2021年度第1四半期安全実績指標PIデータの修正前後表(2/2)

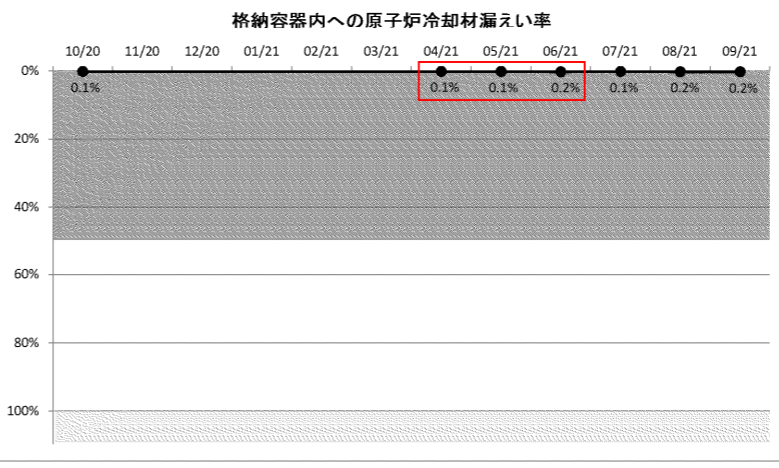
変更前	変更後	変更理由																																																																																																																																																		
<p style="text-align: center;">2021年度第1四半期 安全実績指標(PI) 関西電力株式会社 高浜発電所 4号機</p> <p>格納容器内への原子炉冷却材漏えい率</p> <table border="1" data-bbox="216 520 1231 609"> <thead> <tr> <th></th> <th>07/20</th> <th>08/20</th> <th>09/20</th> <th>10/20</th> <th>11/20</th> <th>12/20</th> <th>01/21</th> <th>02/21</th> <th>03/21</th> <th>04/21</th> <th>05/21</th> <th>06/21</th> </tr> </thead> <tbody> <tr> <td>格納容器内への原子炉冷却材漏えい率</td> <td>0.002</td> <td>0.003</td> <td>0.002</td> <td>0.002</td> <td>-</td> <td>-</td> <td>-</td> <td>-</td> <td>-</td> <td>0</td> <td>0</td> <td>0</td> </tr> <tr> <td>保安規定に定める運転上の制限値</td> <td>2.3</td> <td>2.3</td> <td>2.3</td> <td>2.3</td> <td>2.3</td> <td>2.3</td> <td>2.3</td> <td>2.3</td> <td>2.3</td> <td>2.3</td> <td>2.3</td> <td>2.3</td> </tr> <tr> <td>PI値</td> <td>0.1%</td> <td>0.2%</td> <td>0.1%</td> <td>0.1%</td> <td>#N/A</td> <td>#N/A</td> <td>#N/A</td> <td>#N/A</td> <td>#N/A</td> <td>0.0%</td> <td>0.0%</td> <td>0.0%</td> </tr> <tr> <td>評価</td> <td>緑</td> <td>緑</td> <td>緑</td> <td>緑</td> <td>#N/A</td> <td>#N/A</td> <td>#N/A</td> <td>#N/A</td> <td>#N/A</td> <td>緑</td> <td>緑</td> <td>緑</td> </tr> </tbody> </table> <p>しきい値</p> <table border="1" data-bbox="216 619 421 693"> <tbody> <tr> <td>緑</td> <td>0~50.0%</td> </tr> <tr> <td>白</td> <td>>50.0%</td> </tr> <tr> <td>黄</td> <td>>100.0%</td> </tr> <tr> <td>赤</td> <td>設定なし</td> </tr> </tbody> </table> 		07/20	08/20	09/20	10/20	11/20	12/20	01/21	02/21	03/21	04/21	05/21	06/21	格納容器内への原子炉冷却材漏えい率	0.002	0.003	0.002	0.002	-	-	-	-	-	0	0	0	保安規定に定める運転上の制限値	2.3	2.3	2.3	2.3	2.3	2.3	2.3	2.3	2.3	2.3	2.3	2.3	PI値	0.1%	0.2%	0.1%	0.1%	#N/A	#N/A	#N/A	#N/A	#N/A	0.0%	0.0%	0.0%	評価	緑	緑	緑	緑	#N/A	#N/A	#N/A	#N/A	#N/A	緑	緑	緑	緑	0~50.0%	白	>50.0%	黄	>100.0%	赤	設定なし	<p style="text-align: center;">2021年度第2四半期 安全実績指標(PI) 関西電力株式会社 高浜発電所 4号機</p> <p>格納容器内への原子炉冷却材漏えい率</p> <table border="1" data-bbox="1329 529 2315 617"> <thead> <tr> <th></th> <th>10/20</th> <th>11/20</th> <th>12/20</th> <th>01/21</th> <th>02/21</th> <th>03/21</th> <th>04/21</th> <th>05/21</th> <th>06/21</th> <th>07/21</th> <th>08/21</th> <th>09/21</th> </tr> </thead> <tbody> <tr> <td>格納容器内への原子炉冷却材漏えい率</td> <td>0.002</td> <td></td> <td></td> <td></td> <td></td> <td></td> <td>0.002</td> <td>0.002</td> <td>0.003</td> <td>0.002</td> <td>0.004</td> <td>0.003</td> </tr> <tr> <td>保安規定に定める運転上の制限値</td> <td>2.3</td> <td>2.3</td> <td>2.3</td> <td>2.3</td> <td>2.3</td> <td>2.3</td> <td>2.3</td> <td>2.3</td> <td>2.3</td> <td>2.3</td> <td>2.3</td> <td>2.3</td> </tr> <tr> <td>PI値</td> <td>0.1%</td> <td>#N/A</td> <td>#N/A</td> <td>#N/A</td> <td>#N/A</td> <td>#N/A</td> <td>0.1%</td> <td>0.1%</td> <td>0.2%</td> <td>0.1%</td> <td>0.2%</td> <td>0.2%</td> </tr> <tr> <td>評価</td> <td>緑</td> <td>#N/A</td> <td>#N/A</td> <td>#N/A</td> <td>#N/A</td> <td>#N/A</td> <td>緑</td> <td>緑</td> <td>緑</td> <td>緑</td> <td>緑</td> <td>緑</td> </tr> </tbody> </table> <p>しきい値</p> <table border="1" data-bbox="1329 627 1534 701"> <tbody> <tr> <td>緑</td> <td>0~50.0%</td> </tr> <tr> <td>白</td> <td>>50.0%</td> </tr> <tr> <td>黄</td> <td>>100.0%</td> </tr> <tr> <td>赤</td> <td>設定なし</td> </tr> </tbody> </table> 		10/20	11/20	12/20	01/21	02/21	03/21	04/21	05/21	06/21	07/21	08/21	09/21	格納容器内への原子炉冷却材漏えい率	0.002						0.002	0.002	0.003	0.002	0.004	0.003	保安規定に定める運転上の制限値	2.3	2.3	2.3	2.3	2.3	2.3	2.3	2.3	2.3	2.3	2.3	2.3	PI値	0.1%	#N/A	#N/A	#N/A	#N/A	#N/A	0.1%	0.1%	0.2%	0.1%	0.2%	0.2%	評価	緑	#N/A	#N/A	#N/A	#N/A	#N/A	緑	緑	緑	緑	緑	緑	緑	0~50.0%	白	>50.0%	黄	>100.0%	赤	設定なし	<p>格納容器内への原子炉冷却材漏えい率について、データを修正。 (入力データの誤り)</p>
